STAFF REPORT

# Old Metairie Neighborhood Conservation District

Docket No. OM-28-23

Amend OM-23-21 with variances to the side-yard setback requirement for a raised terrace and to the fence height requirements.

FIGURE 5

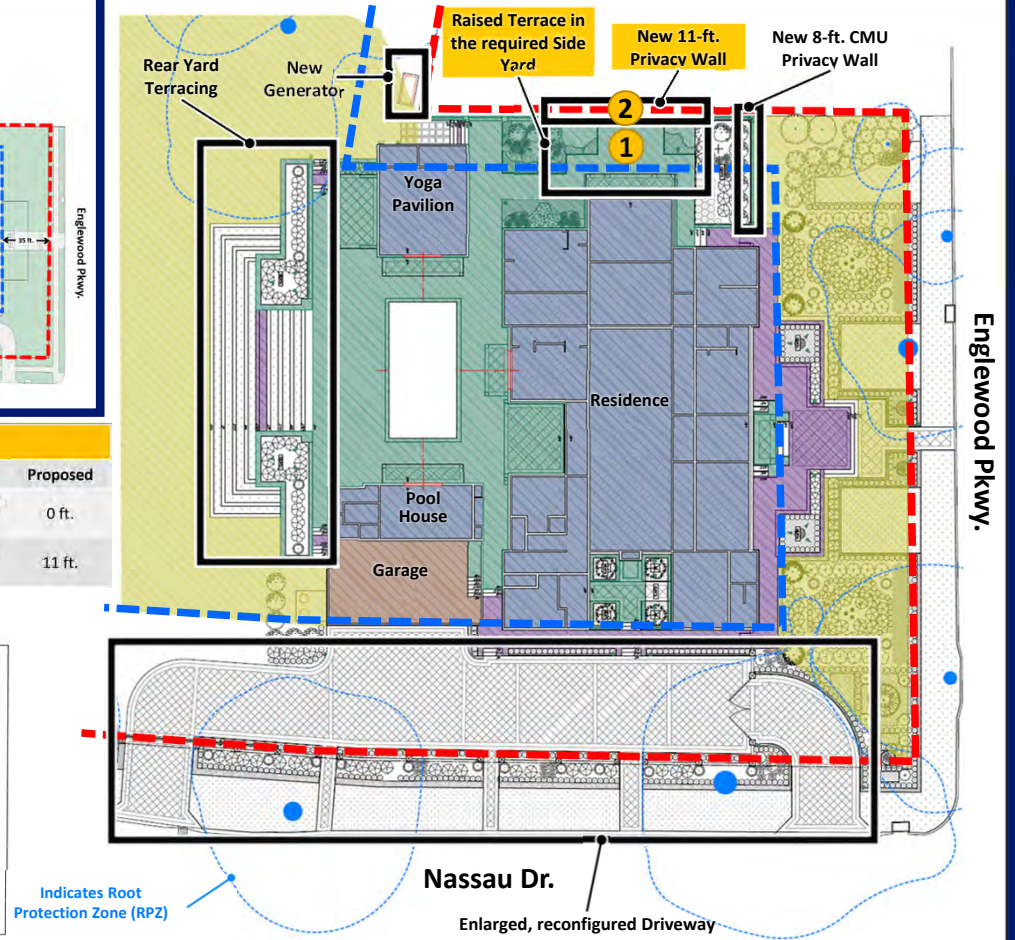
4. The applicant proposes a 3.5-ft.-tall uncovered raised terrace in the required side yard on the north side of the property. The 3.5 ft. represents the elevation of the lowest floor. Per Sec. 40-741.c, an open terrace not greater in elevation than the lowest floor may project into a required side yard to a point not closer than five (5) feet to any side lot line. This raised terrace is built to the property line, resulting in a setback of zero ft. This necessitates a five-ft. side-yard setback variance that must be approved by the Board of Zoning Adjustments (BZA).

5. It must be noted that this raised terrace was not previously approved under OM-23-21, as the previous drawings did not provide sufficient detail in order to do a full review in compliance with Sec. 33-2.25. - Site plan. Specifically, the drawings referred to it as a “Courtyard” only and did not denote that it was raised. Additionally, no elevations were provided to show that the raised terrace was extended to the property line. (Figure 7). Planning requested elevations showing the raised terrace and the support structure, but was only given a site plan showing a straight line as shown in Figure 6.

Variances

Regulation	Allowed	Proposed
1 40-741.c	5-ft. setback for raised terrace	0 ft.
2 40-743.5(a)(2)	8-ft. maximum fence height	11 ft.

FIGURE 10

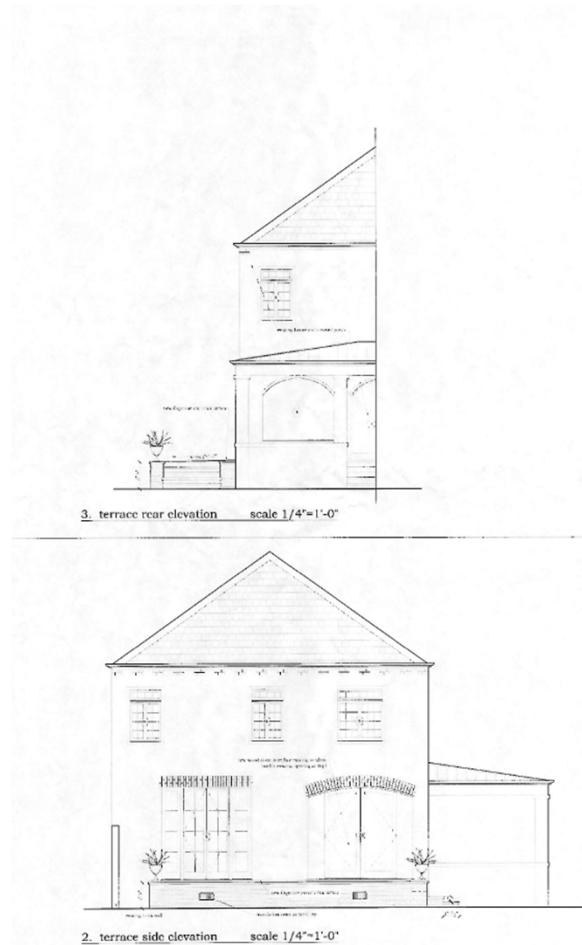
7. Due to the location of the property on Englewood and the zoning of the other properties along Englewood, the only other property that can be considered is 18 Englewood. The property at 18 Englewood has a raised terrace which is not raised to a height of 3.5 feet and is set back 45 feet from the property. (Figures 10 & 11)

FIGURE 12

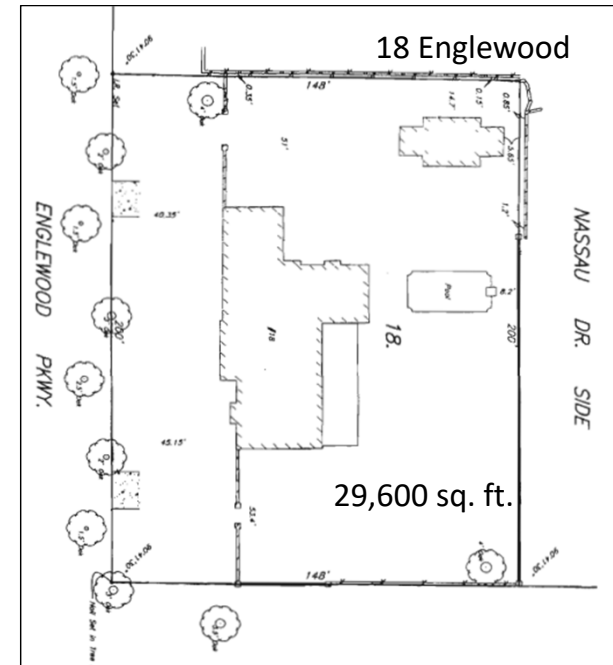
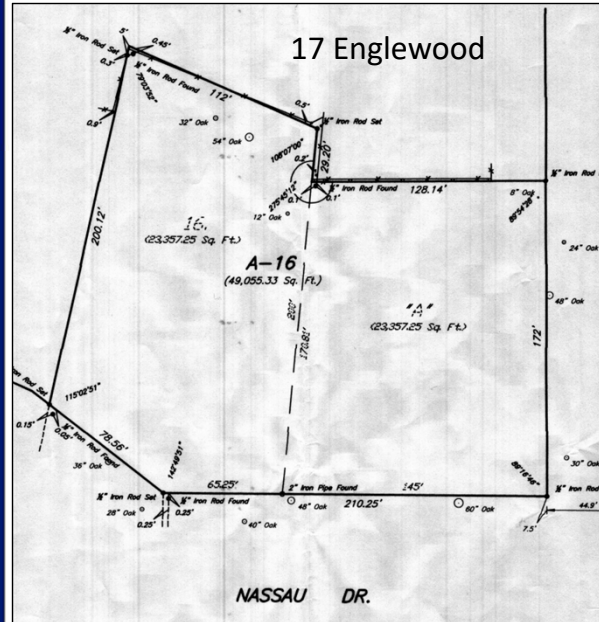
- The legislative exception or variance is the minimum amount needed to relieve a hardship that is unique to the property
    - i. The petitioned property is approximately 49,000 sq. ft. so there is sufficient room to accommodate a raised terrace which would comply with the required 5-foot setback (Figure 12). Furthermore, no hardship has been stated by the applicant for why they cannot comply with the regulations.

FIGURE 17

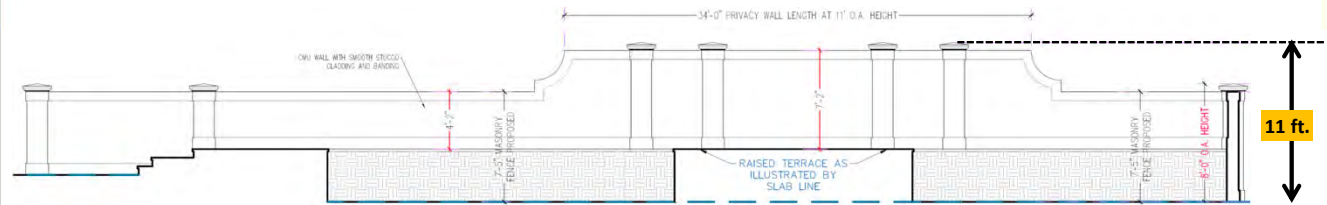
8. The applicant proposes a privacy fence across the raised terrace along the north side property line, including a 34-ft.-long section at 11 ft. in height measured from the lowest adjacent grade, which in on the neighboring property to the north (15 Englewood Pkwy.). Per Sec. 40-743.5.2, a fence not to exceed a height of eight (8) feet may be erected along side lot lines. As such, the proposed 11-ft.-tall fence requires a fence height variance that must be granted by the BZA. This variance is not acceptable, as the proposed privacy fence also does not conform to the purpose or the architectural principles as set forth in Sec. 33-3.65.5.1. For comparison, 18 Englewood added a fence in 2016 with a height of 6',3".

Variance		
Regulation	Allowed	Proposed
40-743.5(a)(2)	8-ft. maximum fence height	11 ft.
